Re: Data Gaps Analysis Report, Shepley's Hill Landfill, Devens, Massachusetts
Contract No. GS-10F-0230J, Delivery Order W912WJ-05-F-0037

Data Gaps Analysis Report, Shepleys Hill Landfill, Devens, MA

Follow-up Comment Letters and Final Response to Comments

Figure 3-1
Correlation of Arsenic vs. ORP
Data Gaps Analysis Report
Shepley's Hill Landfill

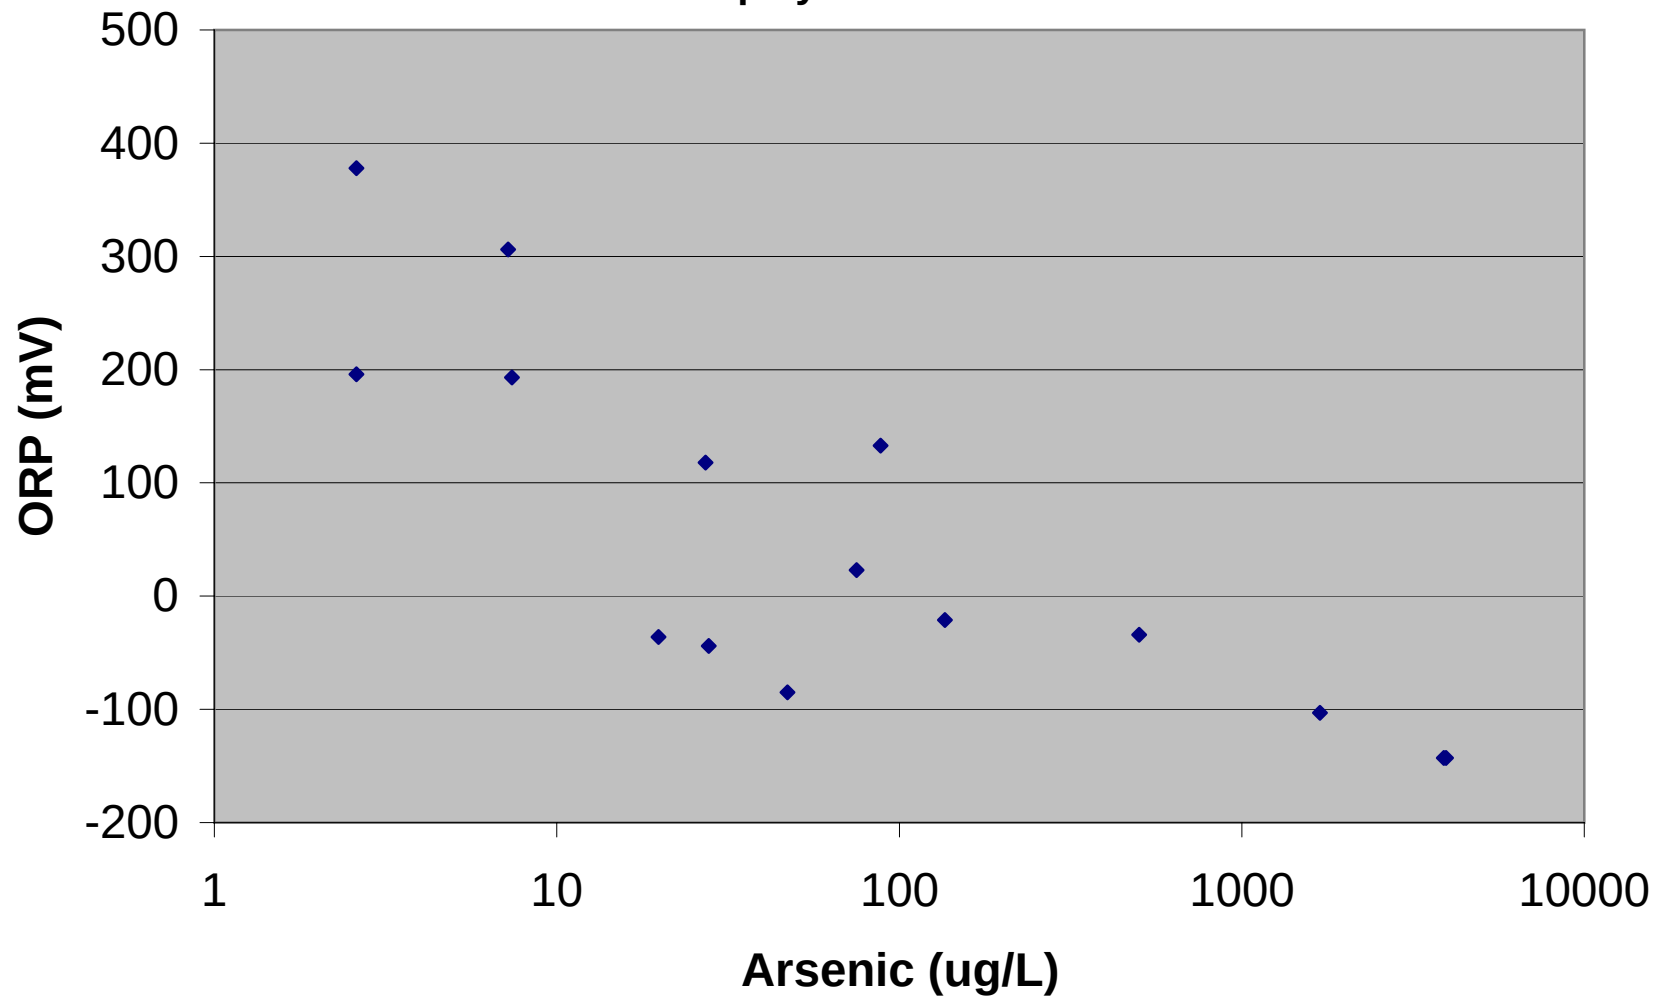
40. Page 18, Section 3.2.3: Please note that the extent of the negative correlation between As concentration and ORP is not fully defined by the range of data used to construct Figure 3-1. There are data from the SHL system that extend to considerably lower ORP, and these values are associated with low dissolved As concentrations. See, e.g., http://www.epa.gov/ord/scienceforum/2005/pdfs/regionposter/Stein_Regions29.pdf.

Figure 3-3
Correlation of Arsenic vs. Iron
Data Gaps Analysis Report
Shepley's Hill Landfill

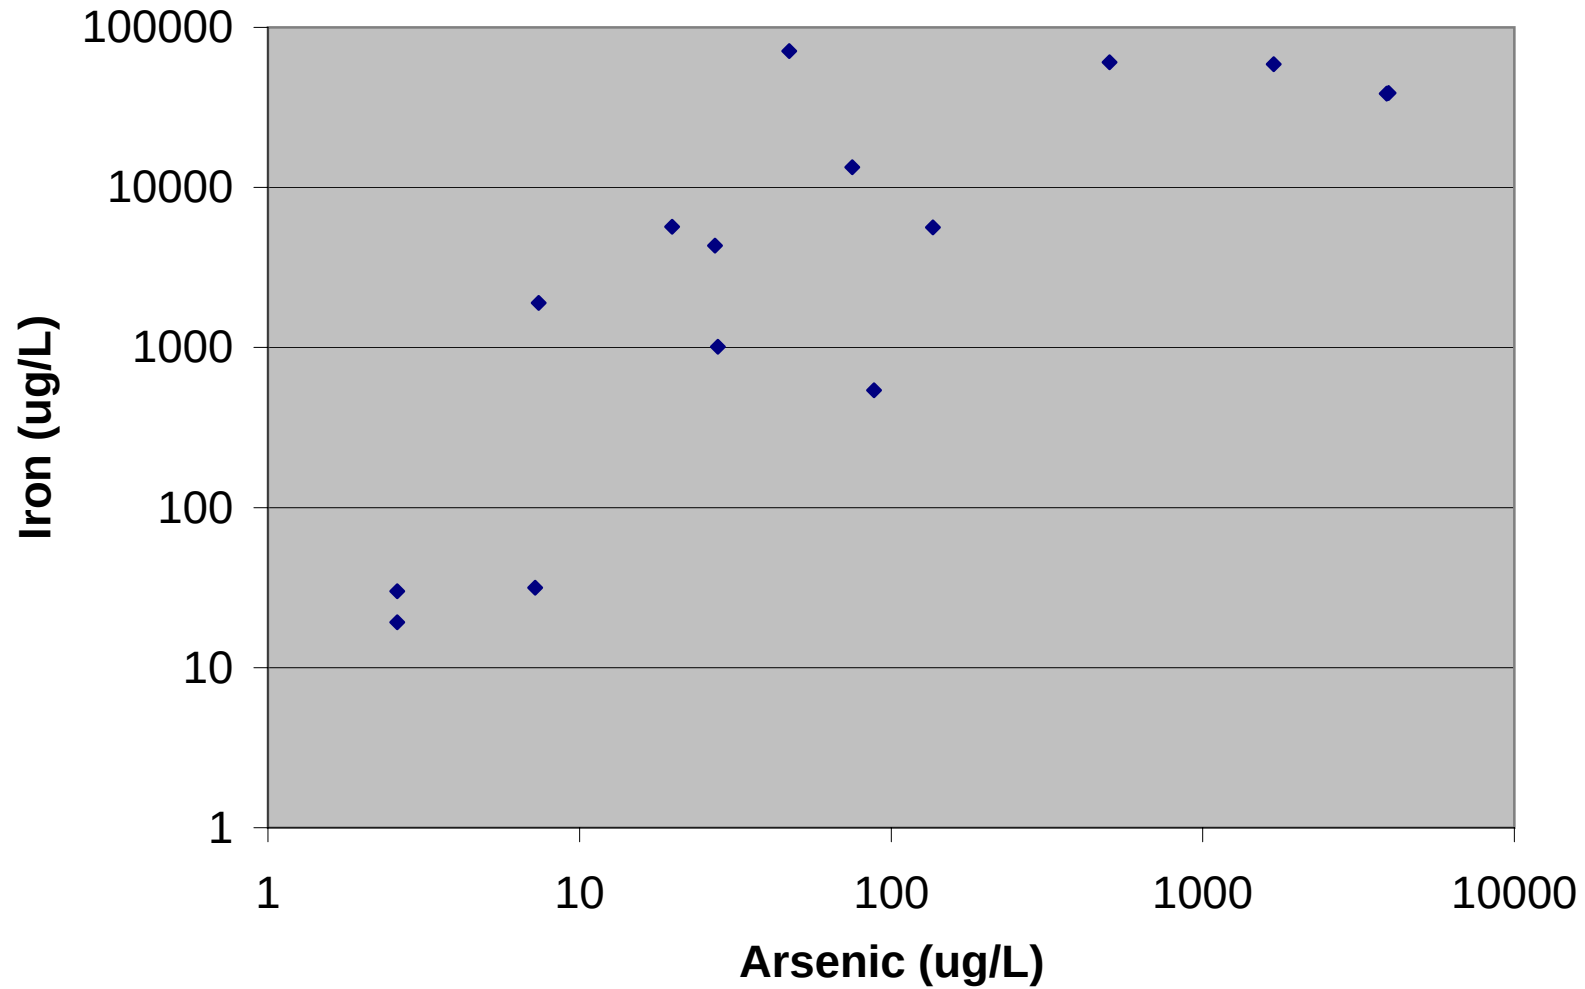
32. Page 13, Section 3.2, Page 18, Section 3.2.3, and Figure 3-3: The relationship between As and iron documented in Figure 3-3 indicates that there is a partial dependence of As on soluble iron, primarily in the mid- to lower-concentration range (note that these data are plotted on a logarithmic scale). However, at higher concentrations there appears to be a weakening of this correlation. Given that the disposal of lead arsenates is identified as part of the “contaminated fill material” (pg. 13), further data collection is warranted to better delineate the potential sources of landfill-derived As. See, also, general comments 3 and 8

Response 32: A positive correlation between dissolved arsenic and iron is often attributed to reductive dissolution of ferric oxyhydroxides and release of sorbed arsenic; this mechanism is inferred from the data in Figure 3-3, but the original comment indicates that this correlation breaks down at higher concentrations. The Response suggests that the solubility limit of siderite (FeCO_3) controls ferrous iron concentrations, at a value around 14 mg/L. Please note that this solubility depends upon pH and alkalinity; at $\text{pH} < 7$ and/or if alkalinity is limiting, iron concentrations may be much higher. Also, other geochemical mechanisms may influence iron concentrations, depending upon local conditions.
